Service Bulletin

Bulletin No.: 13-06-01-003

Subject: Excessive Oil Consumption – Perform Oil Consumption Test and/or Install Piston and Piston Ring Kit

Models: 2010-2013 Buick LaCrosse
2011-2013 Buick Regal
2010-2013 Chevrolet Equinox
2010-2013 GMC Terrain
Equipped with 2.4L Engine (RPOs LAF, LEA)

Acceptable Cylinder that Does Not Appear Uniform (Zebra Stripes)

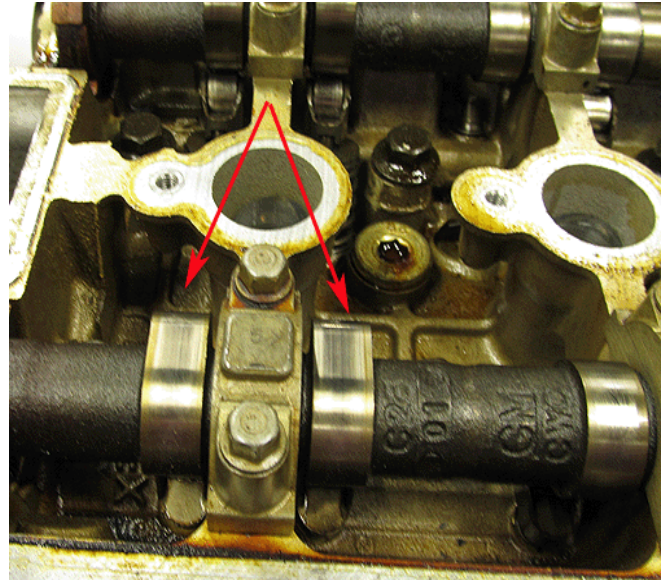
The repair is to replace the pistons and rings. In some cases the bore surface may not have a uniform look to the finish (zebra stripes) as shown below. As a result, some technicians may question whether the engine should be repaired or replaced. After careful evaluation, GM Powertrain has determined that the new pistons and rings will perform correctly in bores that have this appearance so engine replacement should not be

necessary. The cylinder bores do not need any machine or honing work performed on them. Refer to the picture below for acceptable surface finishes.

3409678

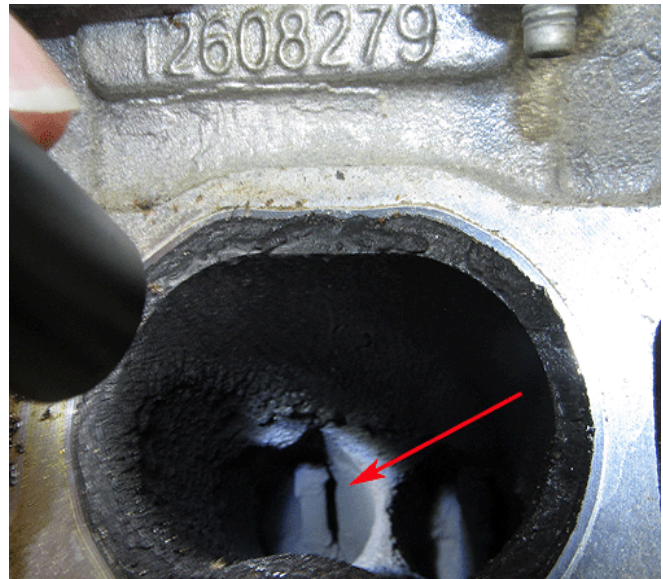
Note: Returned oil consumption engines have been reviewed at engine tear down. It has been determined that these components do not need to be replaced:

- Camshafts and roller follower will have wear markings. This is normal and do not need to be replaced (refer to picture above).
